60446021

PLAN AND PROFILE  
 CHURCH AVE

PP - 1

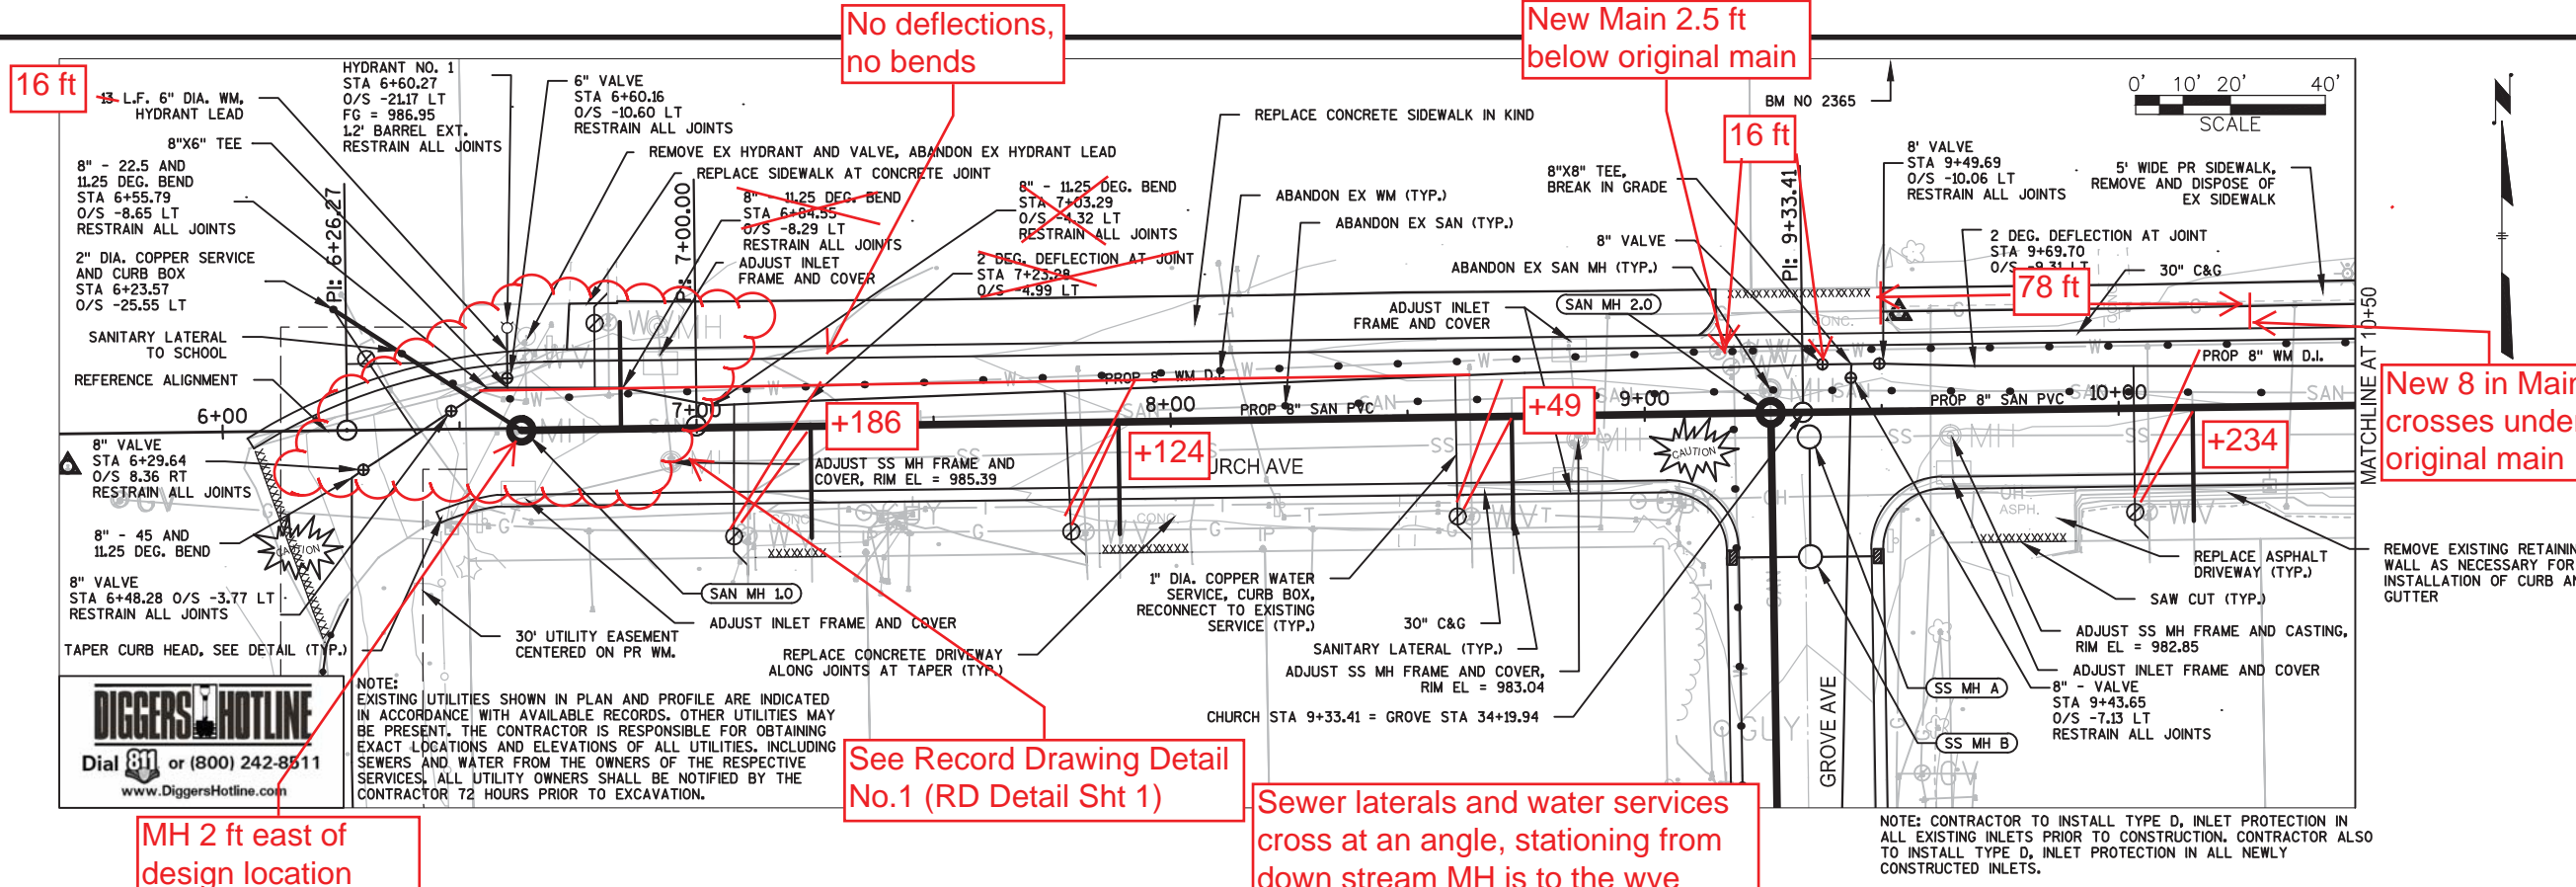
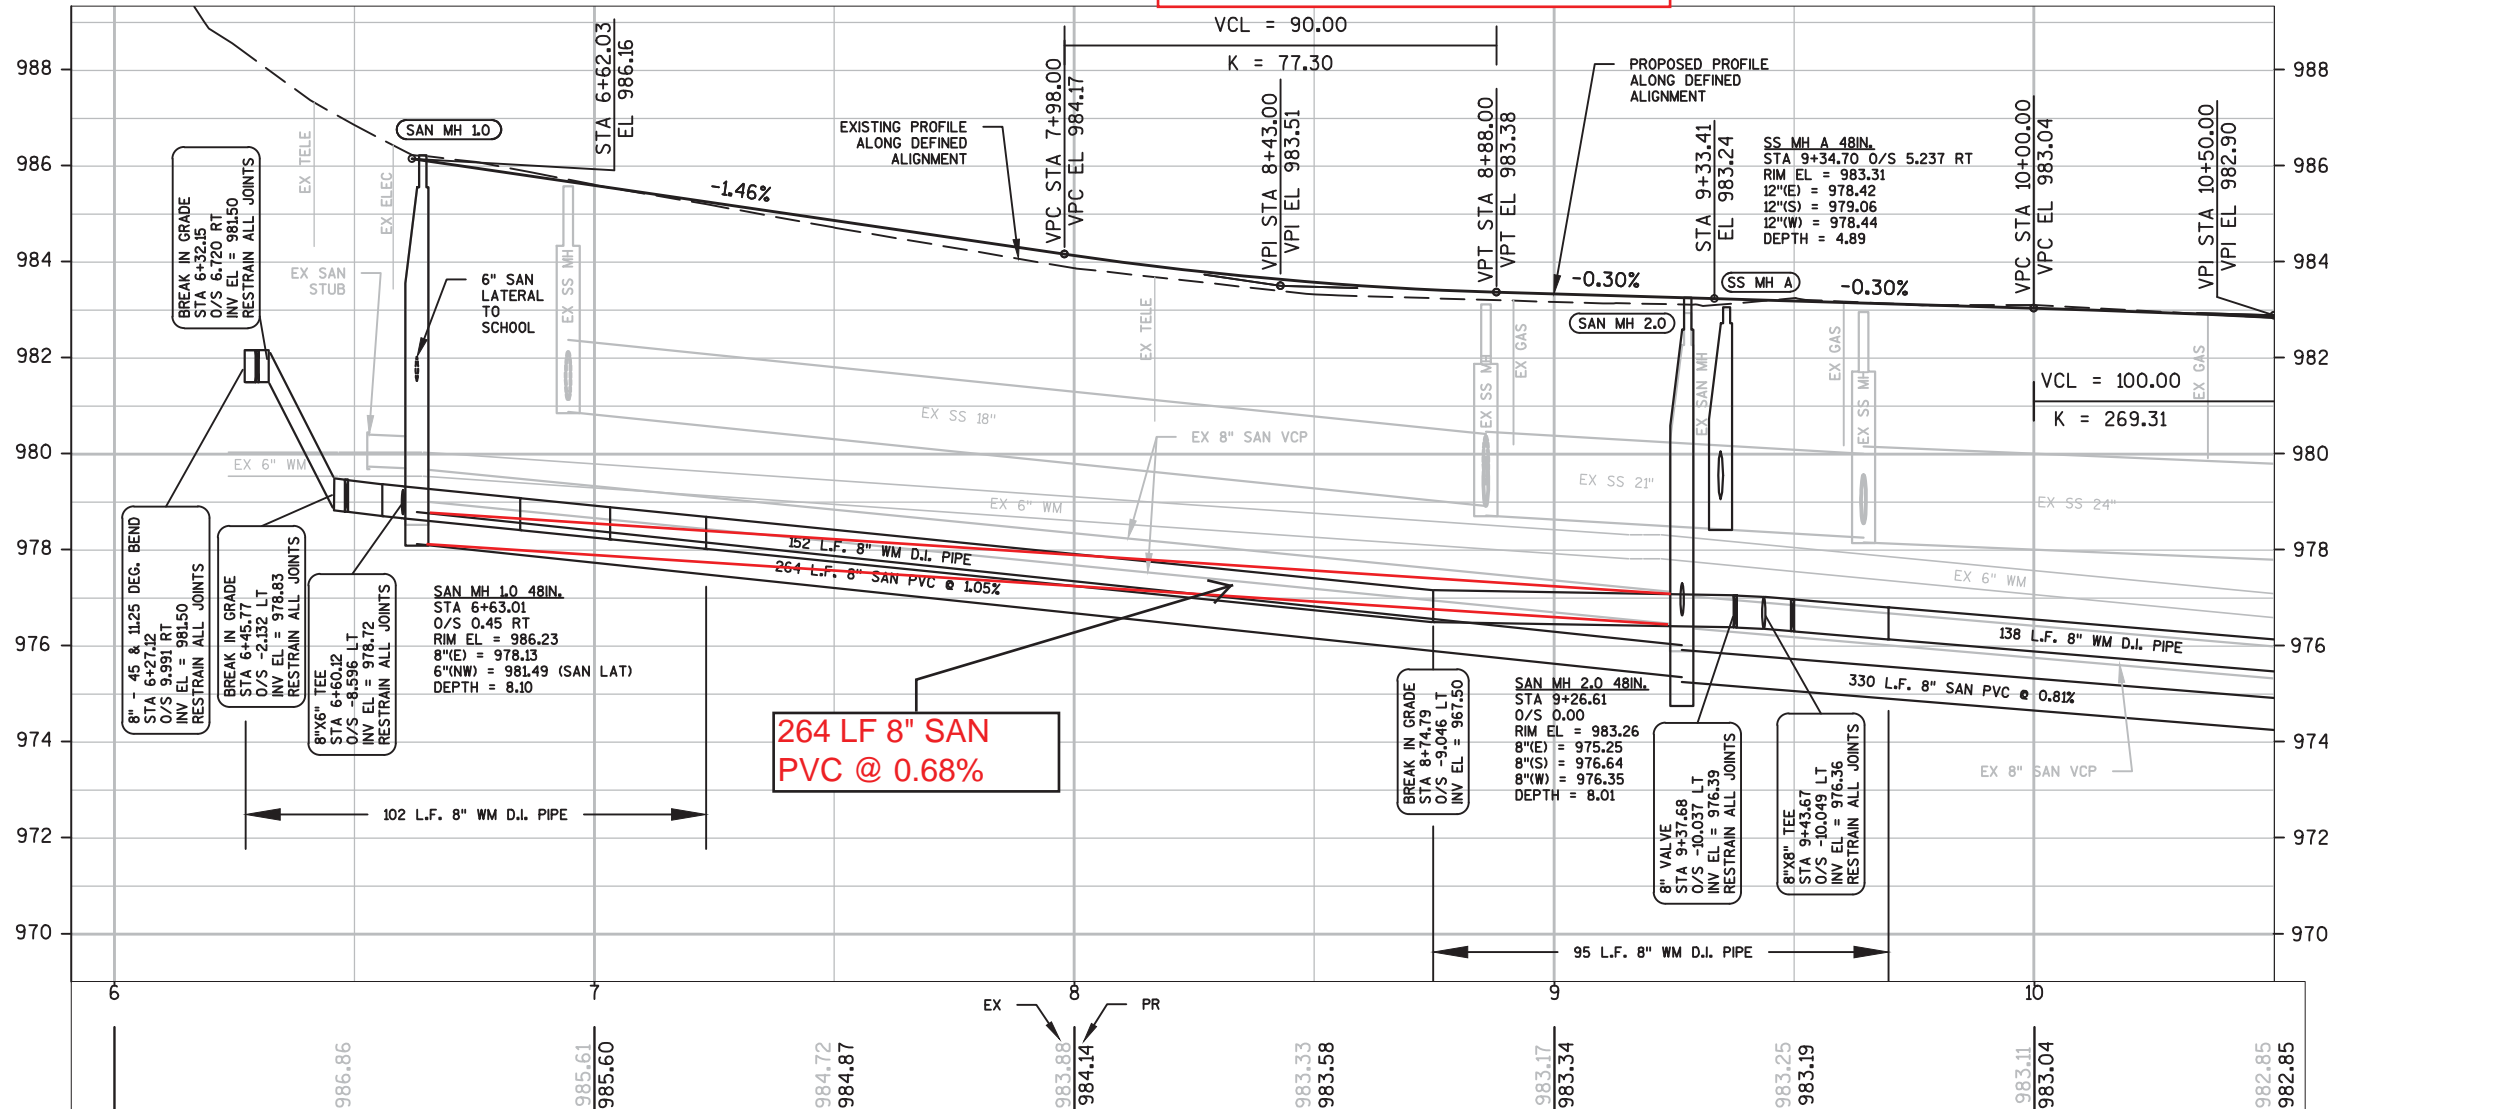
MH 2 ft east of design location

See Record Drawing Detail No.1 (RD Detail Sht 1)

Sewer laterals and water services cross at an angle, stationing from down stream MH is to the wye
